Docket Item #4 A&B

CDD Concept Plan # 2011-0007
Development Special Use Permit #2009-0019

Application	General Data	
Project Name: Alexandria Sanitation Authority (ASA) Expansion	PC Hearing:	October 4, 2011
	CC Hearing:	October 15, 2011
	If approved, DSUP Expiration:	January 1, 2020
	Plan Acreage:	10.6 acres (4.84 acres within RPA)
Location: 350 and 400 Hooffs Run Drive (Blocks 29 and 30)	Zone:	CDD #11
	Proposed Use:	Utility (wastewater treatment facility) and Office
	Dwelling Units:	n/a
	Gross Floor Area:	60,000 sf - Office
Applicant: City of Alexandria Sanitation Authority (ASA), by Kenneth Wire	Small Area Plan:	Eisenhower East
	Historic District:	n/a
	Green Building:	Comply with Policy – LEED Silver for office building

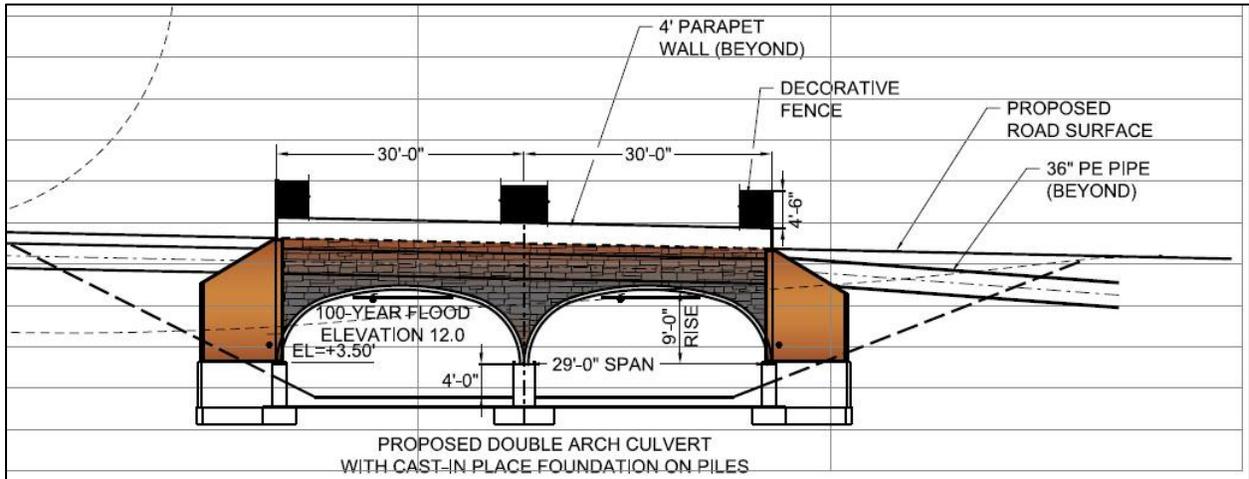
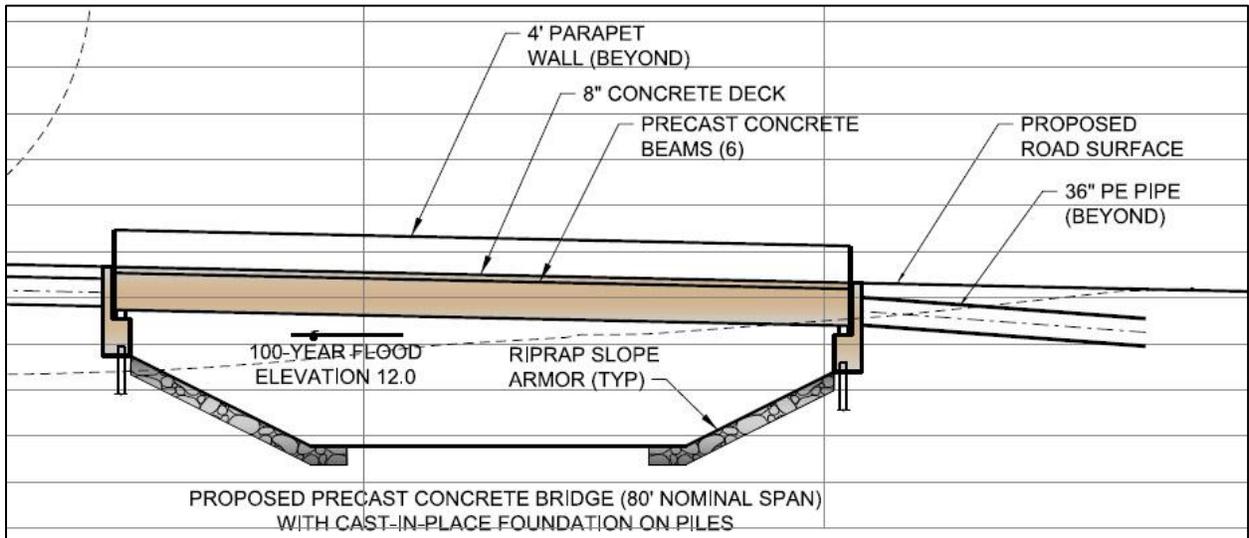
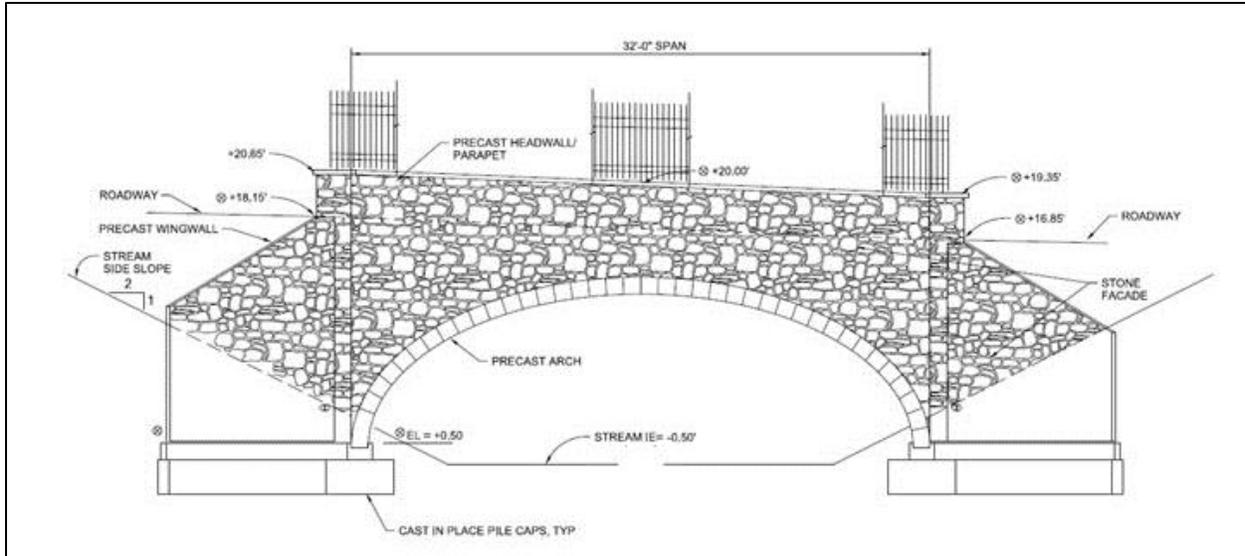
as a double culvert bridge, but may need to be redesigned to a spandrel bridge or single culvert bridge during final site plan depending on possible increases to the size of the pipes and approval from the Army Corps of Engineers (see Attachment #1 for possible bridge designs).

36. The design of the bridge shall be submitted as part of the first final site plan for the tanks and may be revised to the satisfaction of the Directors of P&Z, T&ES, and RP&CA. The design of the bridge shall be consistent with one of the three options provided in Attachment #1. The WQIA and floodplain analysis shall be amended to reflect the proposed bridge design. (P&Z) (T&ES) (RP&CA)
